# Access Compliance Report

## Public Rights-of-Way

### (Curb Ramps)

Intersection ID: 10033482	Main Street: OLD_PINEVILLE_RD	Cross Street: N/A	Location: NE
ADA ID: C85805C39169	Ramp Type: Perp	Initial Pass/Fail: Pass	Overall Compliance: No
Severity Score: 10			
Codes/Mitigation Info/Possible Solution		Field Measurements/Component Compliance

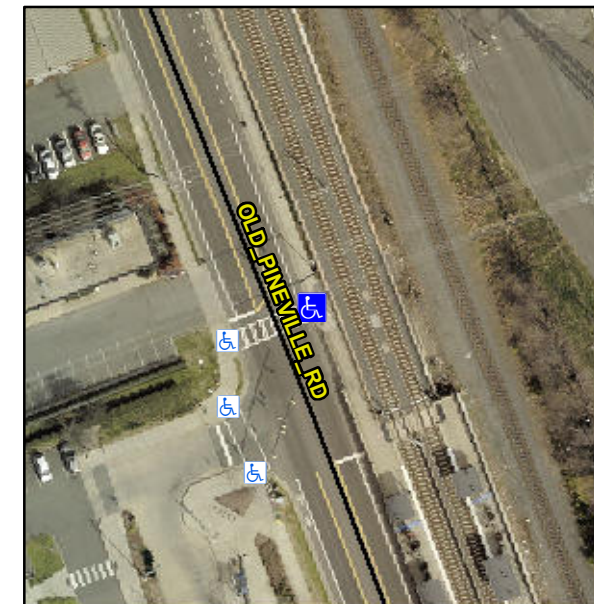
**Remove & Replace Entire Ramp.**

**Not Found, R304.2.1, R304.2.2-Perp, R304.3.2-Para, R304.5.3, R305.2**
